DART SERVICE INSTRUCTION

TO AMEND INSTALLATION INSTRUCTIONS D350-607-3 Rev.D,
INSTALLATION INSTRUCTIONS D350-607-4 Rev. C AND
INSTRUCTIONS FOR CONTINUED AIRWORTHINESS ICA-D350-607 REV. 6
REF TCCA STC: SH94-14
REF FAA STC: SR00213NY
REF EASA STC: EASA.10016996
REF BRAZILIAN STC: 2007S03-03/-04/-05/-06

A	NEW ISSUE	AJS	14.05.16
REV.	DESCRIPTION	BY	DATE
DESIGN	AJS	DART AEROSPACE LTD HAWKESBURY, ONTARIO, CANADA	
DRAWN	AJS		
CHECKED		DRAWING NO.	REV. A
MFG. APPR.	N/A	DSI 9699	SHEET 1 OF 2
APPROVED		TITLE	SCALE
DE APPR.		LUG REPLACEMENT	NTS
DATE	14.05.16	COPYRIGHT © 2014 BY DART AEROSPACE LTD THIS DOCUMENT IS PRIVATE AND CONFIDENTIAL AND IS SUPPLIED ON THE EXPRESS CONDITION THAT IT IS NOT TO BE USED FOR ANY PURPOSE OR COPIED OR COMMUNICATED TO ANY OTHER PERSON WITHOUT WRITTEN PERMISSION FROM DART AEROSPACE LTD.

FIGURE 1: INSTALLATION OF D4775-041 FWD STRUT

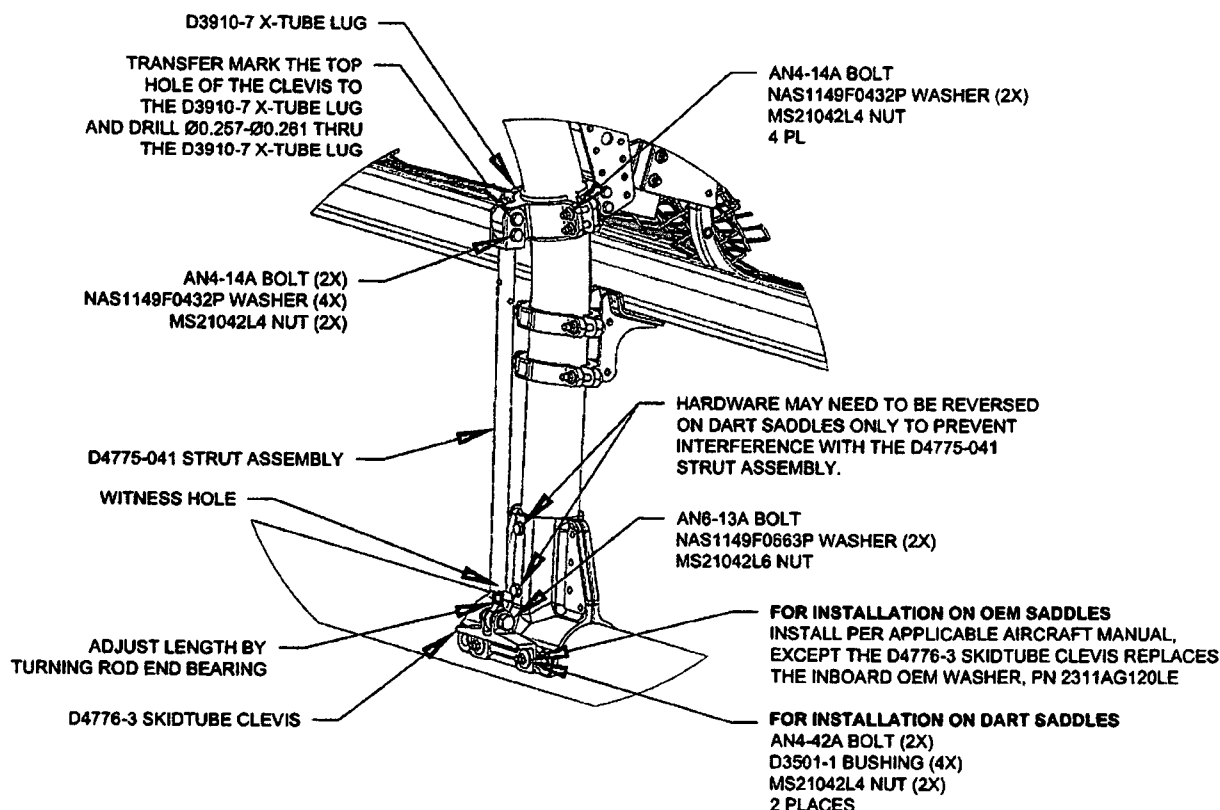
3.1 Substitute the Forward Lower D3910-5 X-Tube Lug with the D3910-7 X-Tube Lug as shown in Figure 1.

3.2 Install the forward D4775-041 Strut Assembly. Transfer mark from the upper hole on the clevis of the D4775-041 Strut Assembly to the D3910-7 X-tube Lug and drill thru the lug $\varnothing 0.257$ - $\varnothing 0.261$ as shown in Figure 1. Touch up chemical conversion coating per MIL-DTL-5541. Check the witness holes located at the bottom end of the D4775-041 Strut Assemblies to ensure that the thread from the rod end extends past the witness hole.
Torque MS21042L4/-4 nuts to 50-70 in-lbs (5.7-7.9 N-m). Torque MS21042L6/-6 nuts to 160-190 in-lbs (18.1-21.5 N-m).
